**SUBJECT:** Savannah River Site's Responses to the Regulatory Comments on the Biennial Effectiveness Monitoring Report (EMR) for Monitored Natural Attenuation (MNA) at the C-Area Burning/Rubble Pit (131-C) and Old C-Area Burning/Rubble Pit (NBN) Operable Unit (U) January 2019 through December 2020 (SRNS-RP-2021-03749, Revision 0, June 2021) SEMS Number: 31

SRS Responses to EPA comments on the Biennial Effectiveness Monitoring Report (EMR) for Monitored Natural Attenuation (MNA) at the C-Area Burning/Rubble Pit (131-C) and Old C-Area Burning/Rubble Pit (NBN) Operable Unit (U) January 2019 through December 2020 (SRNS-RP-2021-03749, Revision 0, June 2021) SEMS Number: 31

Figure 4

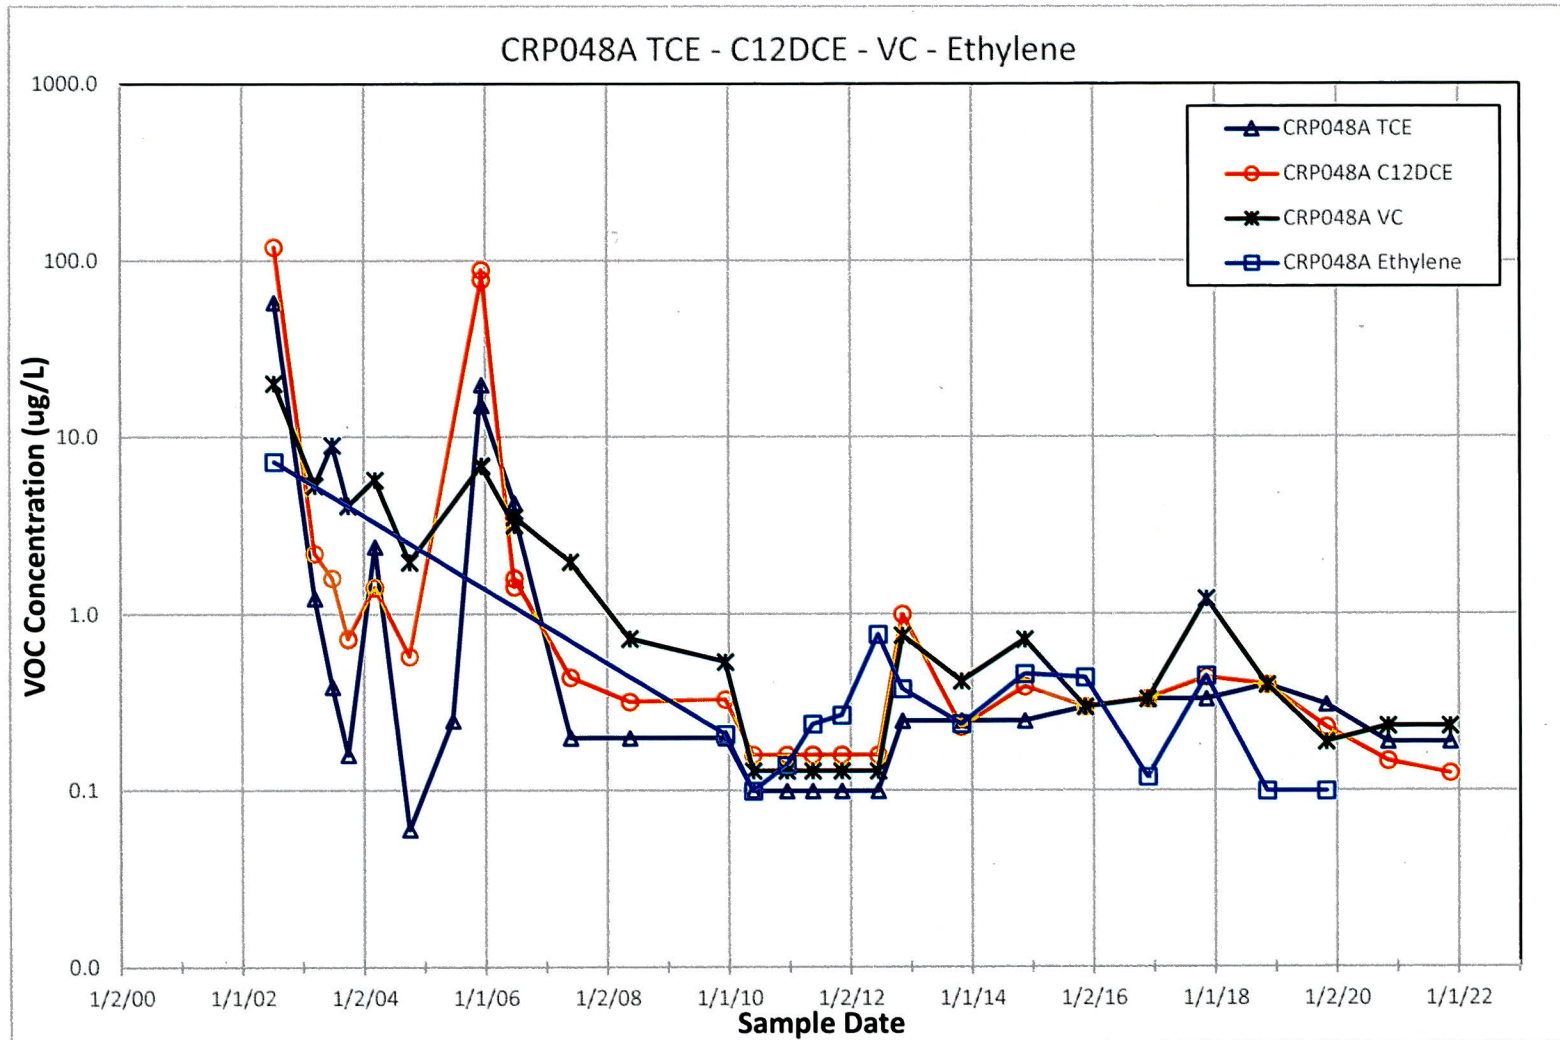
1. **Section 3.2 Hydrogeologic Setting, Page 5 of 34:** It is unclear why the informal nomenclature and sequence of the aquifer zones discussed in this section are not consistent with the aquifer nomenclature and sequence depicted in the cross-section A-A' figures (i.e., Figure 5 [CBRP Plume Cross Section, Fourth Quarter 2000], Figure 6 [CBRP Plume Cross Section, Fourth Quarter 2012] and Figure 7 [CBRP Plume Cross Section, Fourth Quarter 2020]). For example, the cross-sections in Figures 5 through 7 illustrate stratigraphic layers designated as "A-Horizon, AA-Horizon, and Transmissive Zone (TZ)" that are not discussed in this section. Additionally, it is unclear why the MAZ is discussed in the section as one of the three aquifer zones but is not depicted in Figures 5 through 7. *Please revise the Biennial Report to provide discussion of how the A-Horizon, AA-Horizon, and TZ relate to the hydrogeologic setting discussed in this section and why the MAZ is not depicted on cross-sections on Figures 5 through 7.*

4. **Figure 5 CBRP Plume Cross Section, Fourth Quarter 2000, Page 27 of 34; Figure 6 CBRP Plume Cross Section, Fourth Quarter 2012, Page 28 of 34; Figure 7 CBRP Plume Cross Section, Fourth Quarter 2020, Page 29 of 34:** The figures include well cluster CRP 51 as the western-most well cluster depicted on the cross section figures (i.e. Figures 5 through 7); however, Figure 3 (CBRP OU LUC Boundary), Page 25 of 35, indicates the western-most well cluster on the A'-A cross section line is CRP 50 (i.e., CRP 50A/B) and not well cluster CRP 51 (i.e., CRP51A/B). A similar issue is noted with the figures in Appendix D (TCE Plume Maps) and Appendix E (Potentiometric Maps) where well cluster CRP 50 (i.e., CRP 50A/B) is depicted as the western-most well located along the A'-A cross section line. *Please revise all the noted figures, as appropriate, to address the discrepancy in which wells are depicted on the cross sections shown on Figures 5 through 7.*

The Upper Aquifer Zone (UAZ) is divided into three horizons: The A-Horizon; the AA-Horizon; and the Transmissive Zone (TZ). At the CBRP OU the A-Horizon and AA-Horizon comprise the vadose zone, and the UAZ consists entirely of the TZ. For clarity, Figures 5-7 will be revised in the next EMR to remove the A-Horizon and AA-Horizon and rename the TZ as the UAZ. The three layers of the TCCZ (Tan Clay Upper Clay, Middle Aquifer Zone and the Tan Clay Lower Clay) will also be clearly labeled on the revised Figures 5-7 (see attached revised Figure 7).

RockWorks software can project either CRP 50 or CRP 51 onto the cross-section line A-A'. CRP 51 was selected to be projected on the cross-section line, as it had the higher TCE concentrations. The cross-section figures (Figures 5-7) will be revised in future EMRs (see attached revised Figure 7) to depict well cluster CRP 50.

Figure 42. Forward Particle Tracks for Selected Locations near the Reactor Area (WSRC-RP-2000-4096)

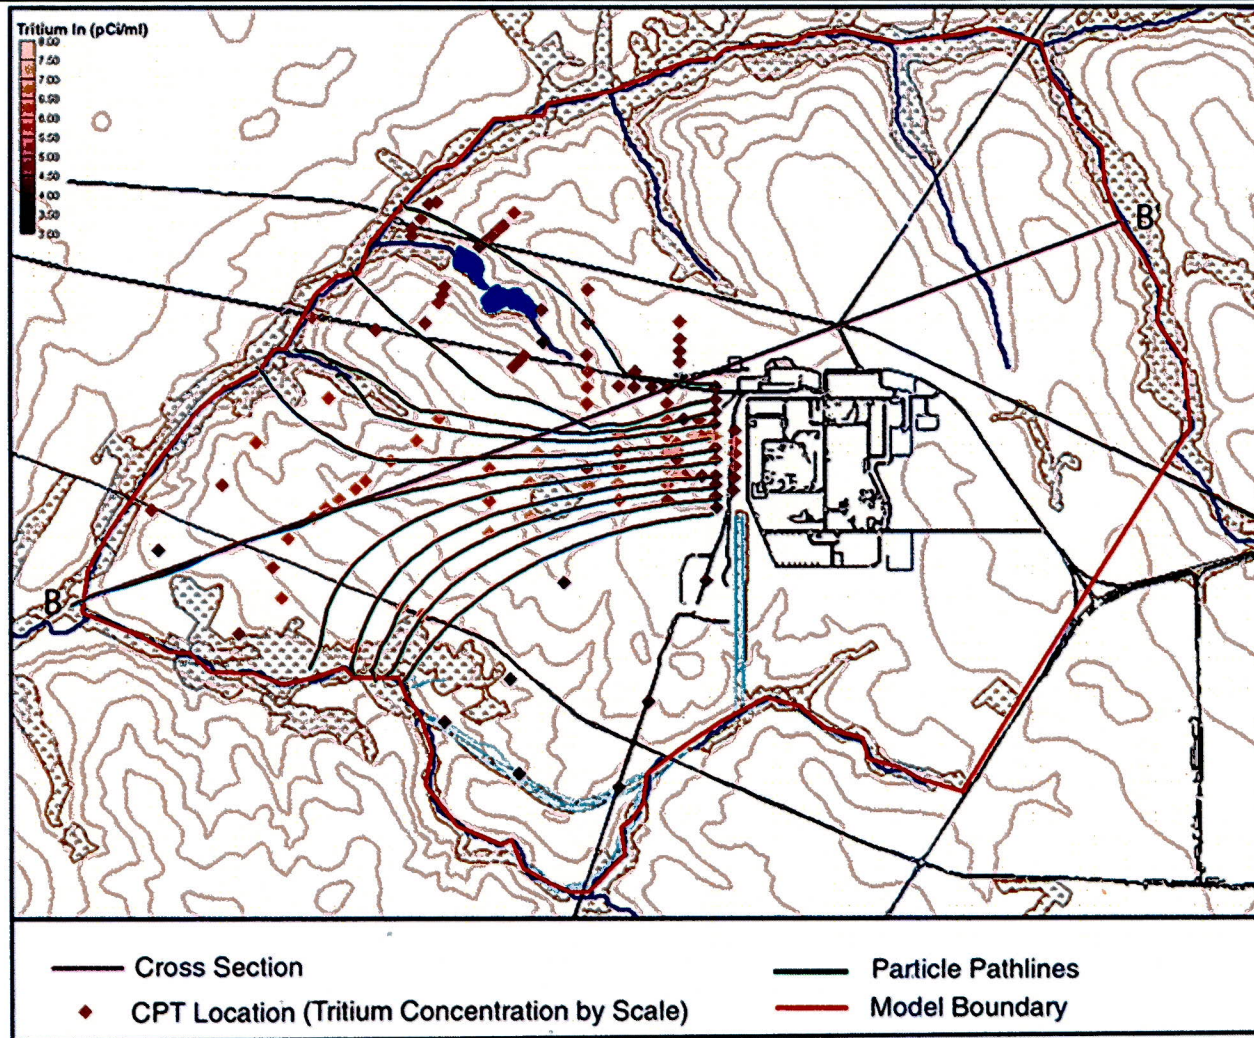
2. **Section 4.3 Groundwater Elevation Measurements and Groundwater Flow Direction, Page 7 of 34:** There are several nested monitoring well clusters (e.g., CRW 10, CRP 18, CRP 20, CRP 22 and CRP 51) installed at the CBRP OU; however, the directions of the vertical groundwater gradients observed between the aquifer units (i.e., UAZ, MAZ, LAZ and GA) are not discussed in this section. *Please revise this section to include a discussion of the upward and/or downward directions of vertical gradients observed at nested monitoring well clusters.*

The horizontal hydraulic conductivity (Kh) tends to be two orders of magnitude greater than the vertical hydraulic conductivity (Kv), which is why the EMR focuses on the horizontal flow. The "Groundwater Modeling for the C-Area Burning/Rubble Pit (U)" report (WSRC-TR-2001-00298), Hydrogeologic Properties (Section 3.2.2) provides the best evaluation of the horizontal and vertical gradients between each of the units. A paragraph will be added to the end of Section 4.3 similar to the following:
